**CITY OF NEWPORT  
PLANNING COMMISSION MEETING  
NEWPORT CITY HALL  
JUNE 09, 2016 – 6:00 P.M.**

<b>To:</b>	Newport Planning Commission	<b>Reference:</b>	Red Rock Square CUP Request
<b>Copies To:</b>	Deb Hill, City Administrator		
	Andy Brunick, Intern		
	MWF Properties, LLC, Applicant		
	Washington County RRA, owner		
	Jon Herdegen, MSA, City Engineer	<b>Project No.:</b>	16020.005
<b>From:</b>	Sherri Buss, RLA AICP, City Planner	<b>Routing:</b>	
<b>Date:</b>	June 1, 2016

The applicant, MWF Properties, LLC, has submitted an application to develop a 42-unit apartment building on a site located in the MX-3 Zoning District, adjacent to the Newport Transit Station. The site is currently vacant. The site plan includes the building, a parking lot, “tot lot” and some open space. The proposed use requires a CUP in the MX-3 District. The housing is proposed to be “workforce” housing that serves workers and families with incomes that meet state program requirements.

EXTERIOR ELEVATIONS

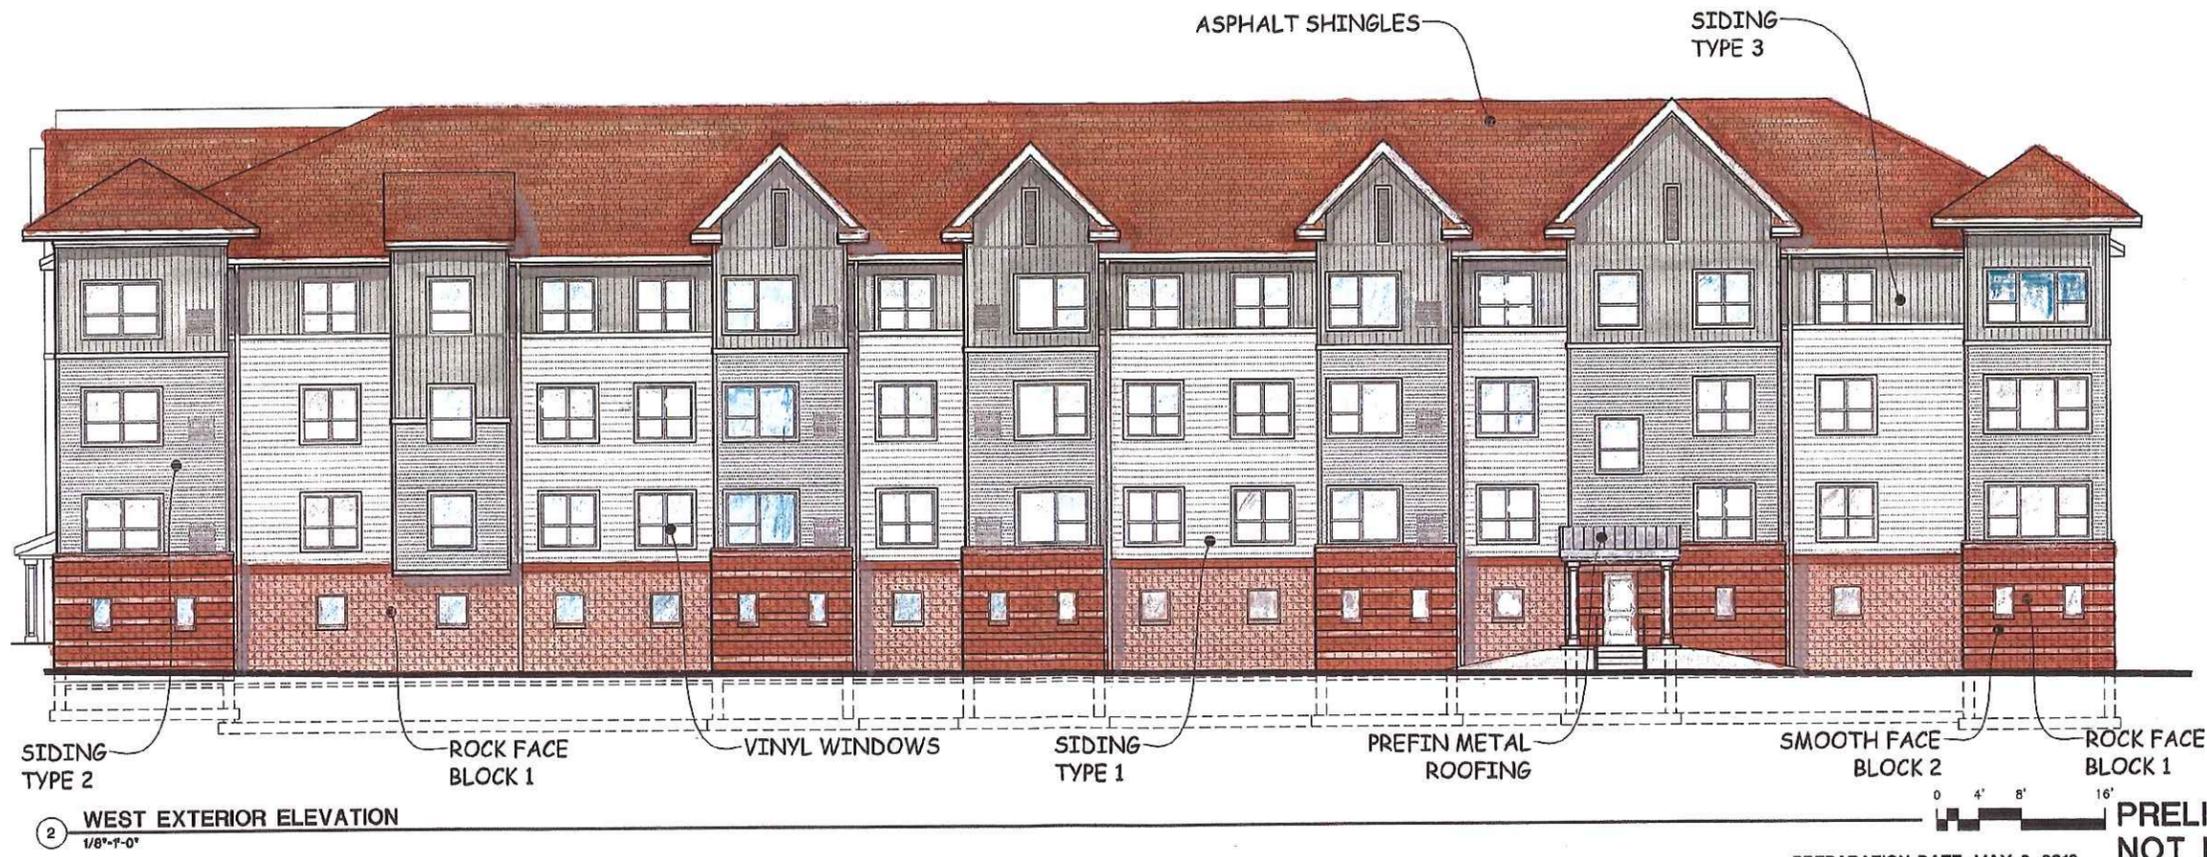
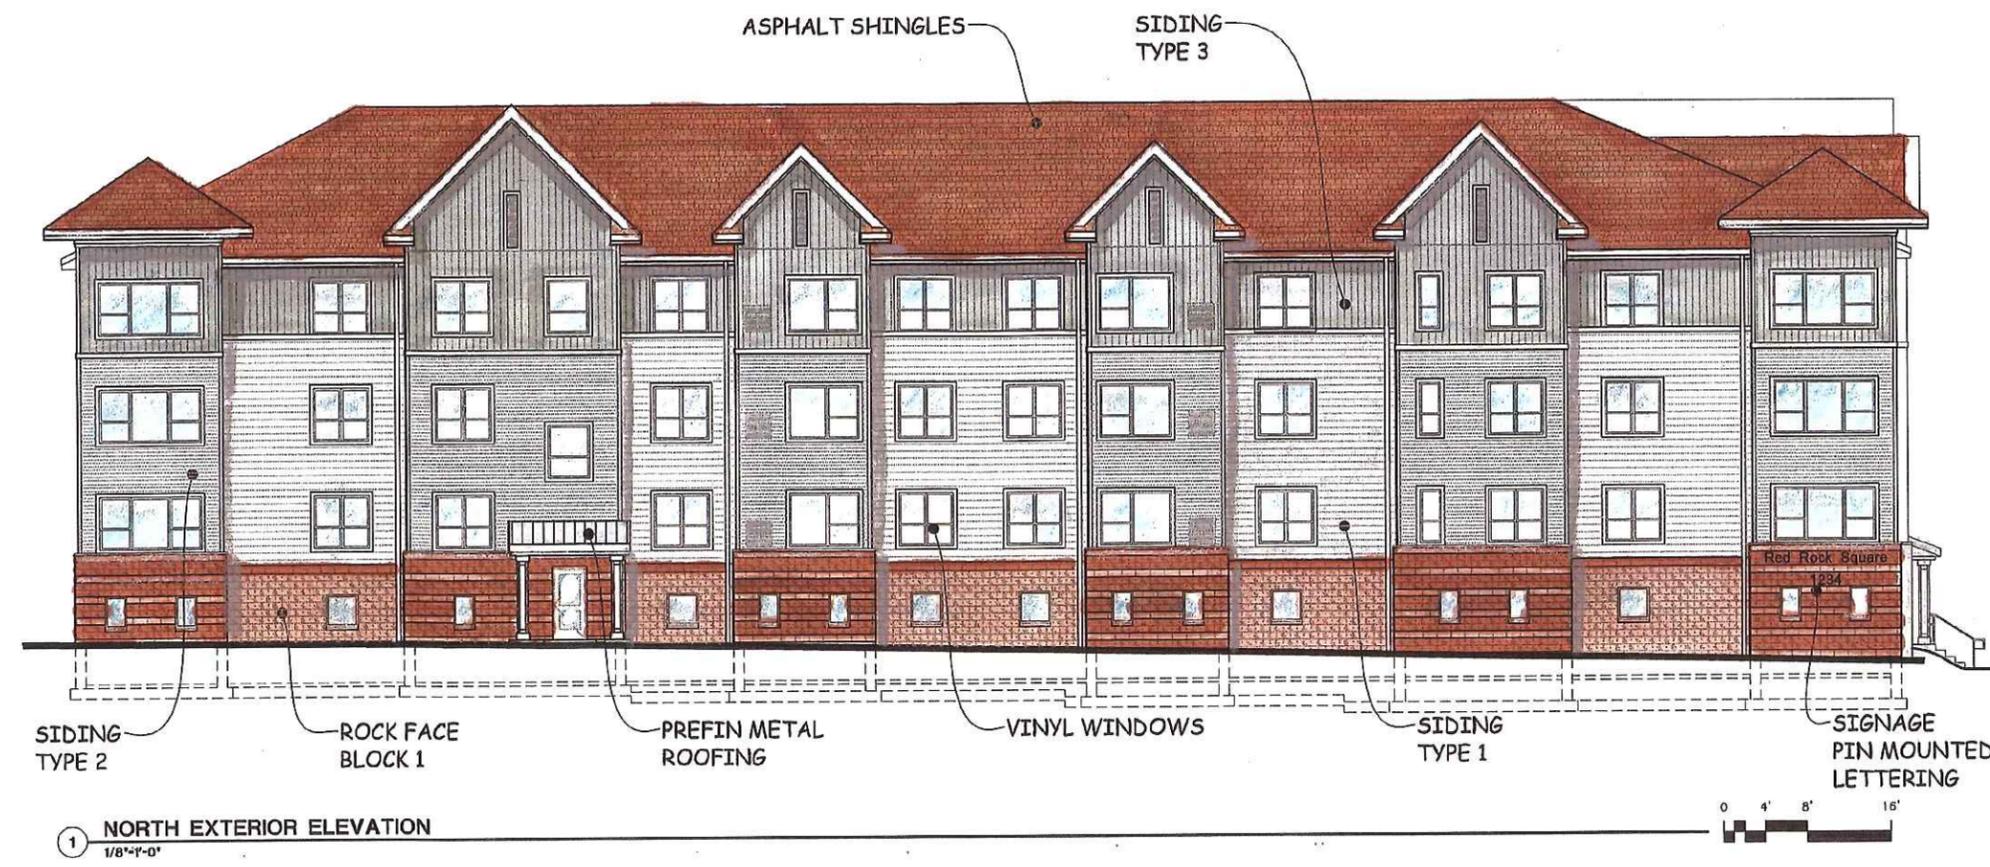
The materials shown on sheet A500 include siding (material not specified), rock face, metal roofing over entries, vinyl windows, smooth face block, and asphalt shingles. The applicant has provided examples of the proposed materials, which are available at City Hall for review prior to the meeting on June 9.

1 SITE PHOTOMETRIC PLAN  
1" = 20'-0"

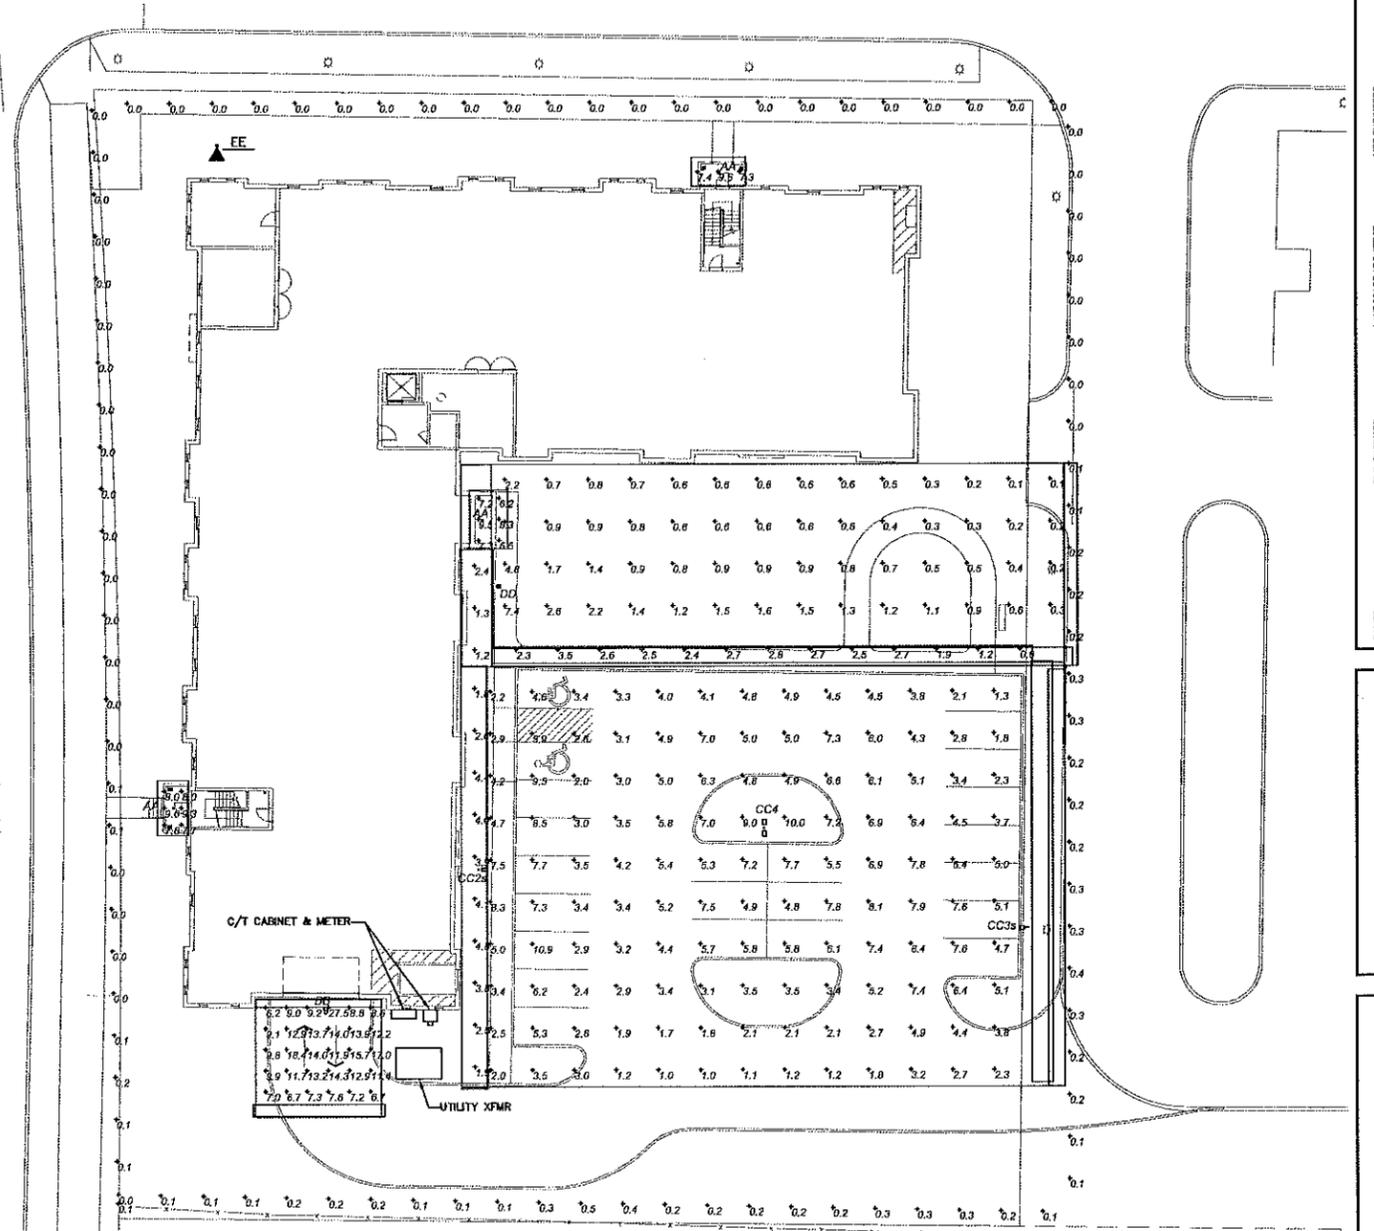
The application included a lighting plan. The lighting on the site must meet the requirements of Subdivision 13 of Section 1330.05 of the ordinance to be “of a downcast, cutoff type, concealing the light source from view and preventing glare from spilling into residential areas.” The applicant submitted a lighting plan (sheet E000) and samples of lighting types that will be used on the site (sheet E001). The lighting plan meets the minimum ordinance standards.

1 SITE PLAN  
1/16" = 1'-0"

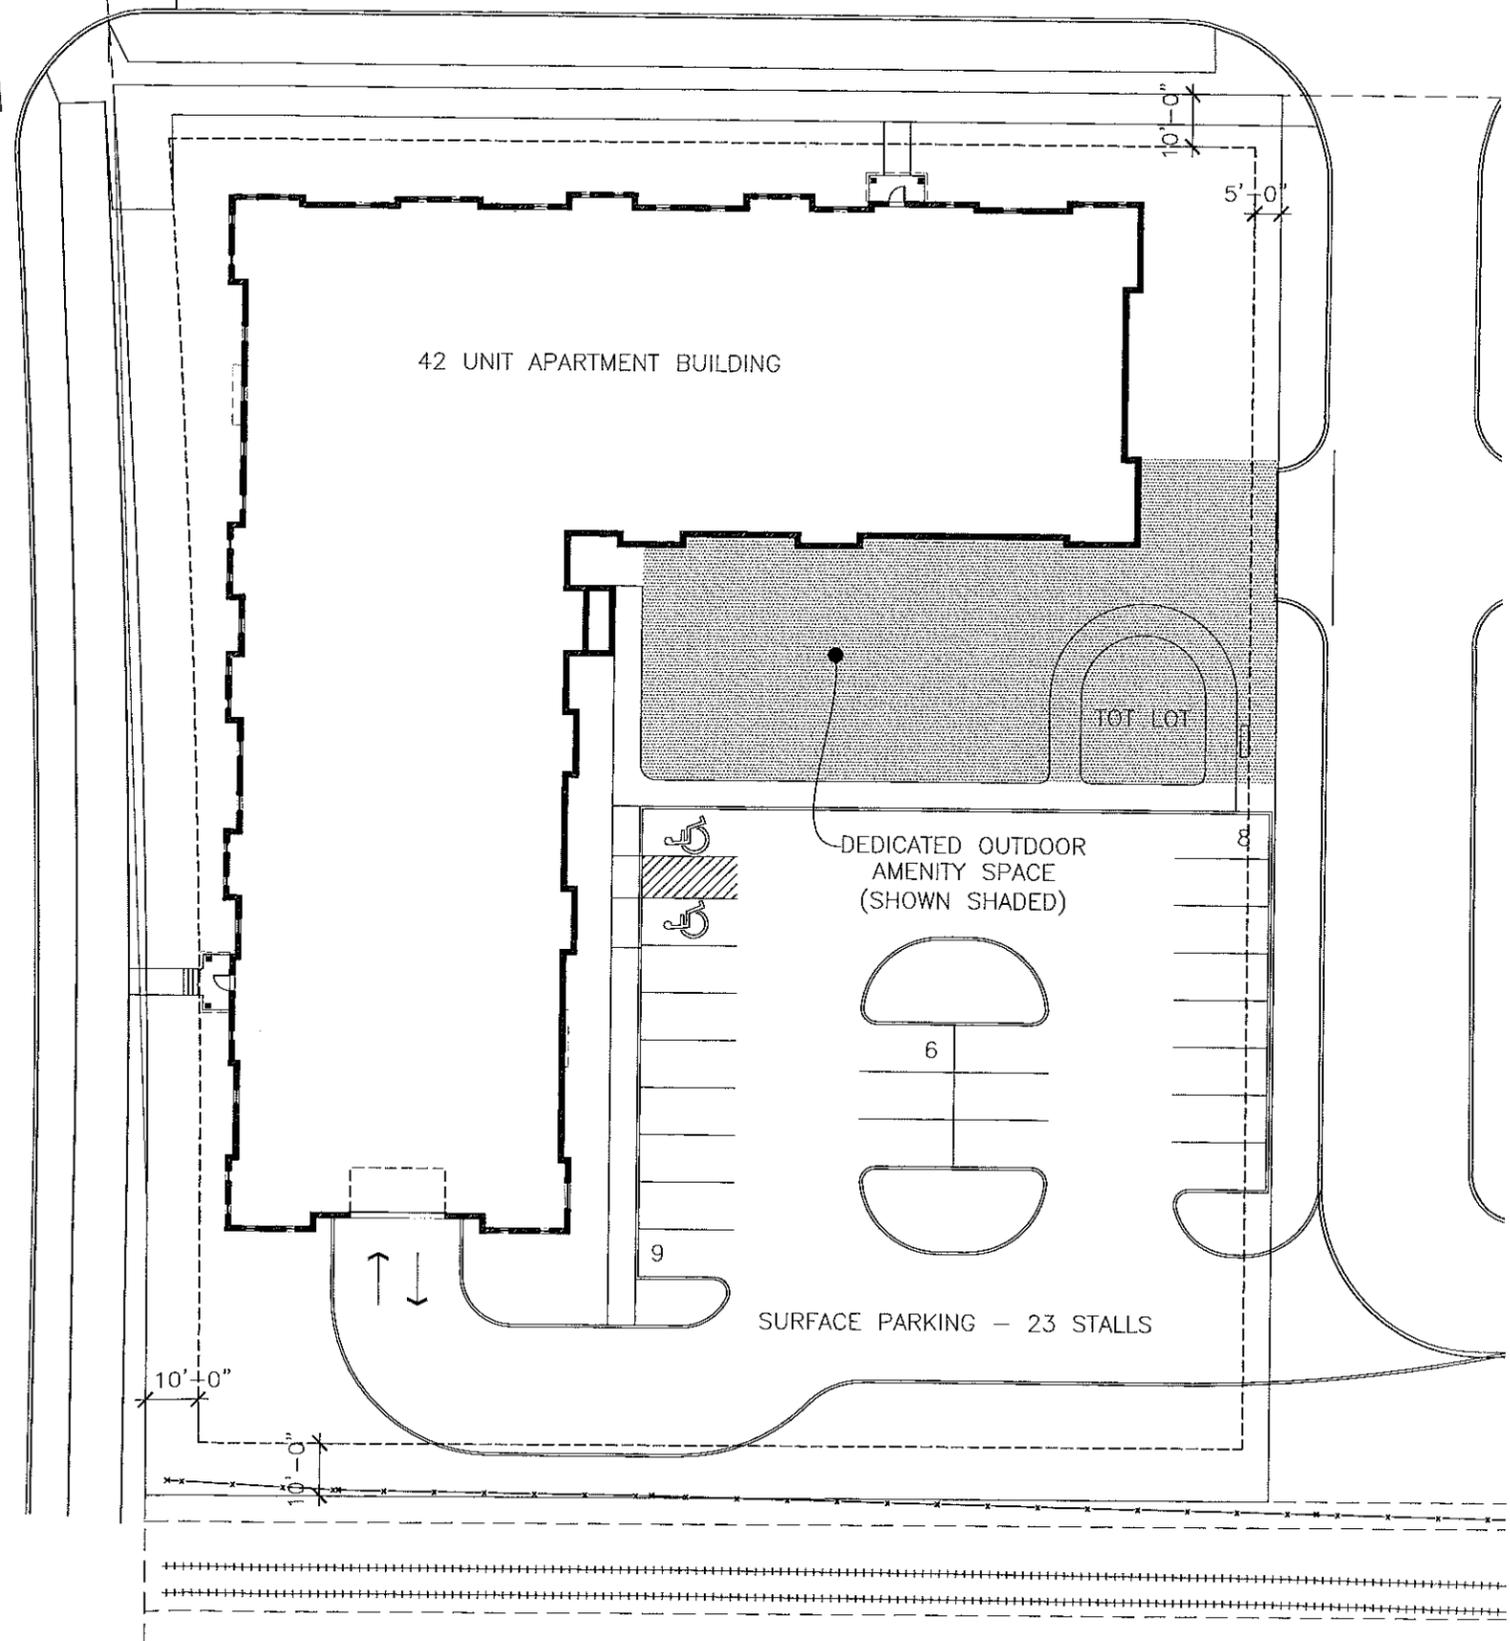
The proposed site plan needs to be revised to provide a 5-foot setback between the parking lot and parcel boundary. The Planner has included the revision requirement in the proposed conditions.

The project plan sheet A200 label an area called “tot lot” and another area called “dedicated outdoor amenity space.” The areas total the minimum 10% open space. The landscape plan shows a few trees in the space, and label the tot lot as “open space.”

The plans do not show seating, amenities, or the components of the “tot lot” or open space area as required by the zoning ordinance. The plans do not describe the likely demographics of the residents of the building, discuss their needs for open space or play facilities, and how these will be met on the site. The nearest city park is more than ¼ mile away (Lions Park) and access would require children or families to cross Maxwell Avenue/21 Street (a county road with significant truck traffic) with no controlled pedestrian crossing.

The Planner has included a proposed condition that the applicants modify the plans to show the proposed seating, plantings and amenities in the “tot lot” and designated open space area to meet the ordinance requirements. The applicant shall submit the revised plan to the City for review by the City’s Park Board. The Park Board shall provide recommendations to the applicant and Council so that the open space areas address the needs of building residents and the City’s ordinance requirements.

2. The applicant shall revise the site plan to provide a five (5)-foot setback between the parking lot and parcel boundary.
3. The applicant shall obtain written permission from the Washington County Regional Rail Authority to eliminate the existing driveway apron shown on the plans and construct the new driveway entrance onto the private driveway that serves the Newport Transit Station.
